PRODUCT INFORMATION NOTIFICATION

PIN: PIN210804A

Subject: Addendum to PIN210804 - Removal of Cypress Logo on Shipping Boxes

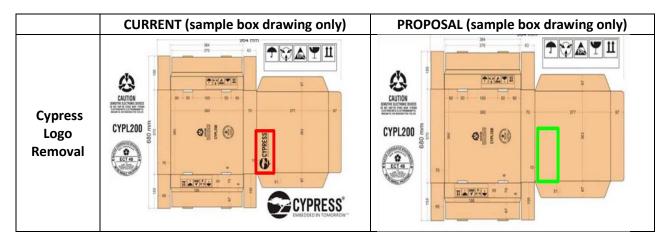
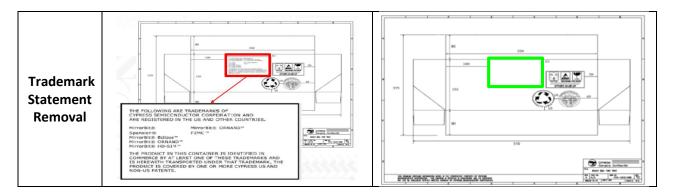
The purpose of this addendum is to update the implementation date of the removal of Cypress logo from shipping boxes. Due to current inventory at the warehouse, the implementation date has been changed from April 2021 to December 2021. It is possible to receive boxes with or without the Cypress logo during the transition period prior to the implementation date.

Cypress announces the removal of the Cypress logo and any trademark statements on the shipping boxes. This is to align Cypress shipping boxes with the current Infineon packaging standards. In addition, the removal of the Cypress logo provides additional security during shipment. There are no changes to ordering part numbers. Product datasheets remain the same and can be downloaded from the Cypress website (www.cypress.com).

This change will be implemented in December 2021. It is possible to receive boxes with or without the Cypress logo during the transition period prior to the implementation date.
